PUB MFR 72 Attachment Pages 54 to 56 of 615

PREAMBLE TO IR (IF ANY):**QUESTION:**

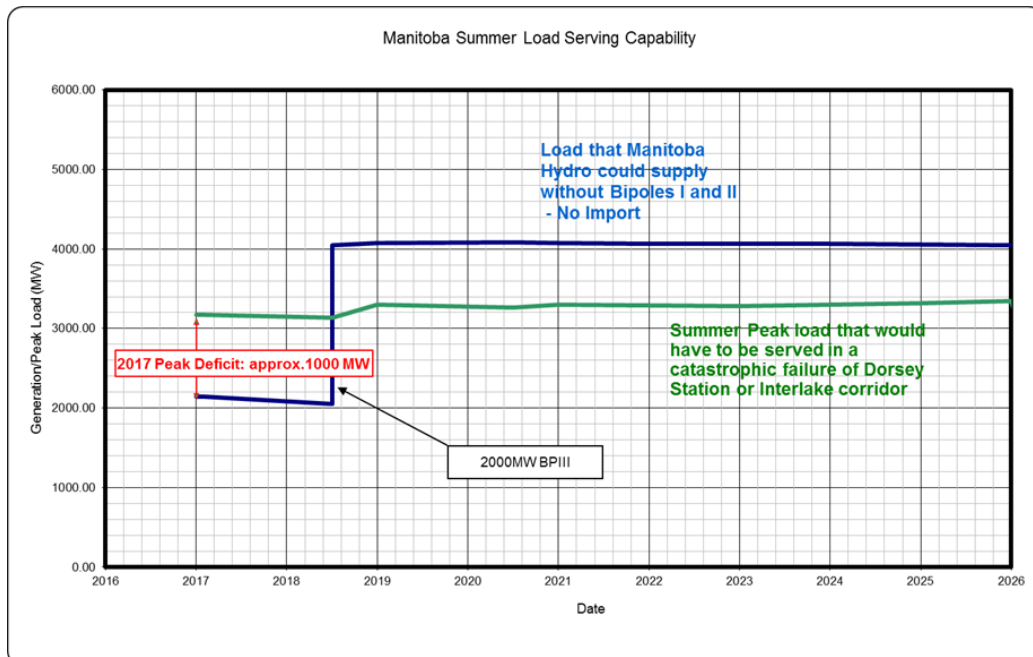
- a) Please update the chart showing the winter peak demand and available resources in the event of a loss of Bipoles I and II, incorporating the 2017 Load Forecast, updated DSM assumptions, and current resource availability.

- a) The plot below shows supply-demand curves in the event of a loss of Bipoles I and II during the winter peak, incorporating the 2017 Load Forecast, updated DSM assumptions, and current resource availability.
